**SUBDIVISION,
PLANNED UNIT DEVELOPMENT,
PLANNING APPROVAL, &
REZONING STAFF REPORT****Date: November 19, 2009**

<u>APPLICANT NAME</u>	Archbishop of Mobile
<u>SUBDIVISION NAME</u>	McGill-Toolen High School Subdivision, Phase 2
<u>DEVELOPMENT NAME</u>	McGill-Toolen High School Subdivision, Phase 2
<u>LOCATION</u>	South side of Old Shell Road extending from the West side of Lafayette Street to the East side of Catherine Street; Northwest corner of Old Shell Road and Kilmarnock Street, and North side of Old Shell Road between Kilmarnock Street and Catherine Street; Northeast corner of Dauphin Street and Lafayette Street; Northwest corner of Dauphin Street and Lafayette Street; Southeast corner of Old Shell Road and Lafayette Street and extending South along the East side of Lafayette Street 695'+
<u>CITY COUNCIL DISTRICT</u>	Council District 2
<u>PRESENT ZONING</u>	B-2, Neighborhood Business District
<u>PROPOSED ZONING</u>	R-1, Single-Family Residential District
<u>AREA OF PROPERTY</u>	19.03± Acres
<u>CONTEMPLATED USE</u>	<p>Subdivision Approval to create one legal lot of record from three metes and bounds parcels; Planned Unit Development Planning Approval, and Rezoning to amend Mas

SUBDIVISION DETAIL

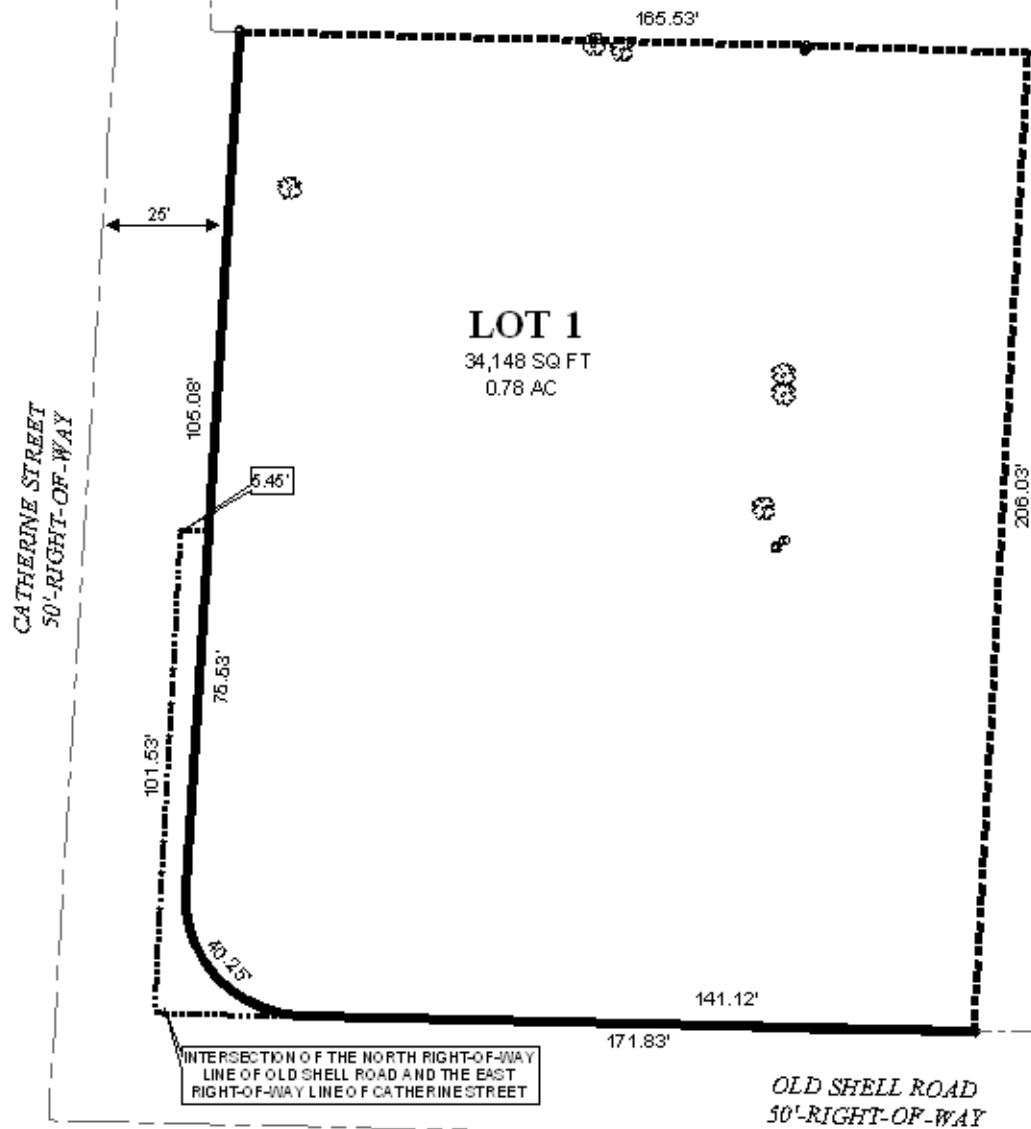
It appears that the applicant has dedicated some right-of-way at the intersection of North Catherine Street and Old Shell Road, so as to comply with Section V.B.16 of the Subdivision

Regulations regarding curb radii; however, it is not labeled as such. The applicant should revise the plat accordingly.

The applicant should also revise the plat to illustrate a 25' minimum building setback line from each street.

- 3) provision of adequate radius, in compliance with Section V.B.16 of the Subdivision Regulations, at the intersection of North Catherine Street and Old Shell Road;

SITE PLAN

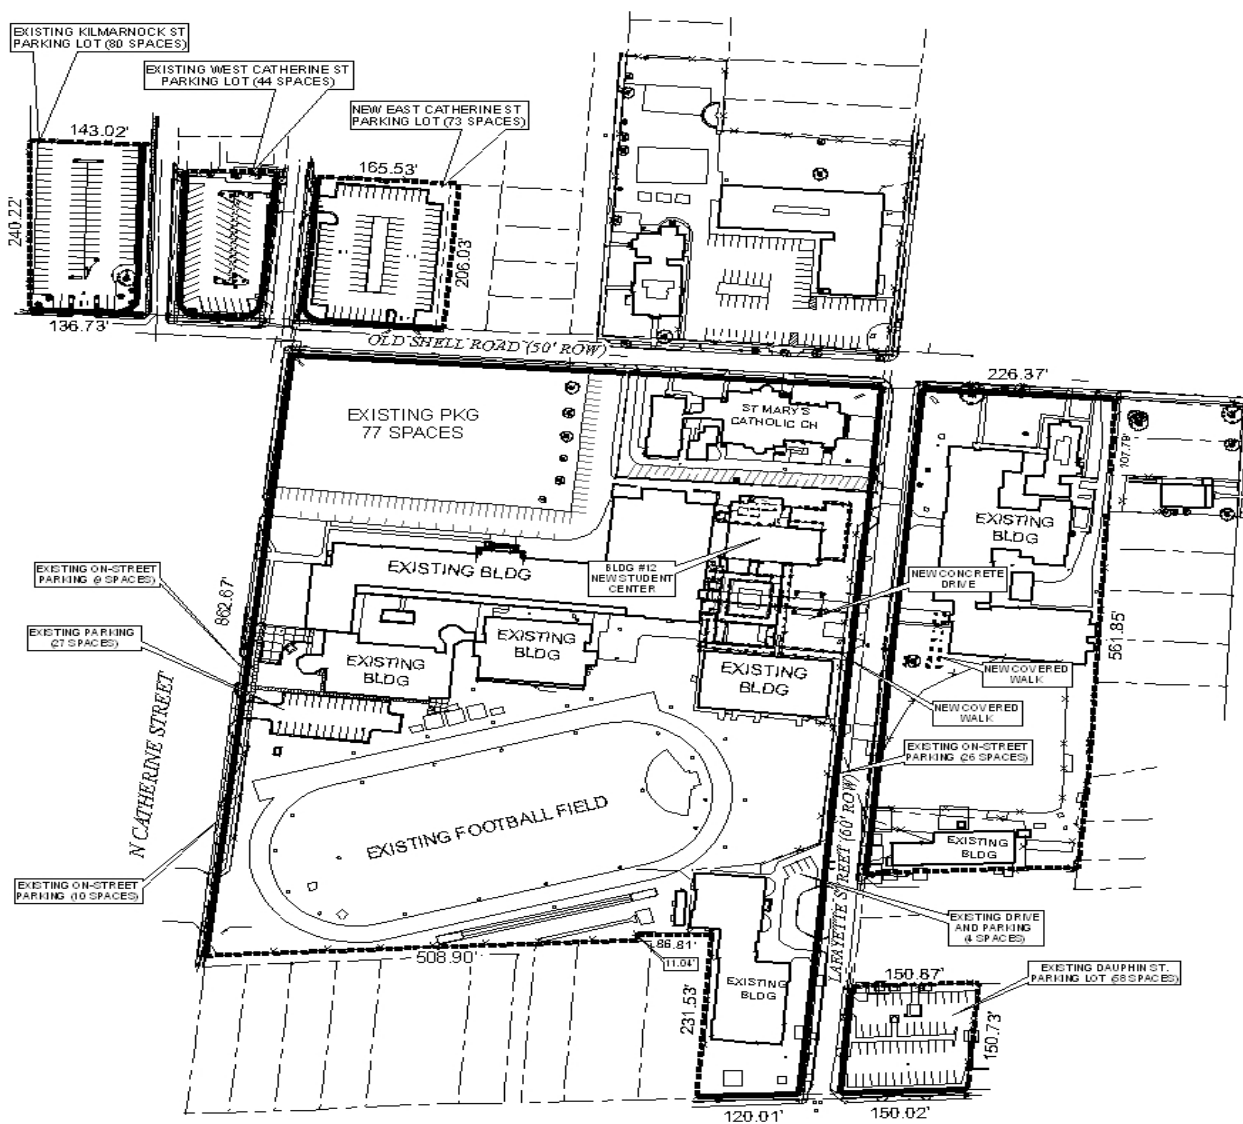
The site plan illustrates the new 19,348 square foot student center, covered walkways, new pavement and landscaping. One issue found is that the covered walkways on either side of Lafayette Street do not appear to meet the required 25' minimum building setback; therefore, the applicant should revise the site plan accordingly. Another potential issue is that (per note on the site plan) the new student center, at maximum, will be 64' in height; this exceeds the 35' maximum height allowance for buildings in R-1, Single-Family Residential Districts. However, relief to exceed said height requirements may be found in Section 64-4.C of the Zoning Ordinance, which states *in any R-1 District, two feet in building height may be added above general height limits for the district for each one foot of side yard provided in excess of ten feet*. With a 50' setback from Lafayette Street (hereto considered a side street), the proposal is well within the requirement.

As illustrated, the Master Plan contains on- and off-street parking. With regards to on-street parking, 19 angled spaces were approved in 2007 Phase I project. In the current application (Phase II), the applicant is proposing 26 parking spaces (designed at 90 degrees) located within the right-of-way of Lafayette Street; these will not be allowed per comments by Traffic Engineering. It should be noted that, with the addition of the new parking lot, the total amount of off-site parking alone exceeds the minimum parking requirements of the Ordinance; thus, all on-street parking could be eliminated without compromising the applicant's objective.

With regard to trees, the applicant has provided a proposed tree plan for the new parking lot, which appears to meet the minimum requirements of Section 64-4 of the Zoning Ordinance for new development. The applicant has also proposed some additional landscaping / trees around the new student center. It has been the position of the Commission for many years, when considering applications for Planned Unit Development, to require some level of compliance in terms of landscaping and tree plantings, depending on scope and project area; and determining the level of compliance that is required has generally been delegated to the Urban Forestry Section of Urban Development. Therefore, the applicant should coordinate with Urban Forestry regarding additional trees in the project area.

- 6) submission of a revised site plan to the Planning Section of Urban Development prior to signing the final subdivision plat;
- 7) compliance with Engineering comments: *(Need to provide documentation if claiming historical credit for detention. Must comply with all storm water and flood control ordinances. Any work performed in the right of way will require a right of way permit);* and
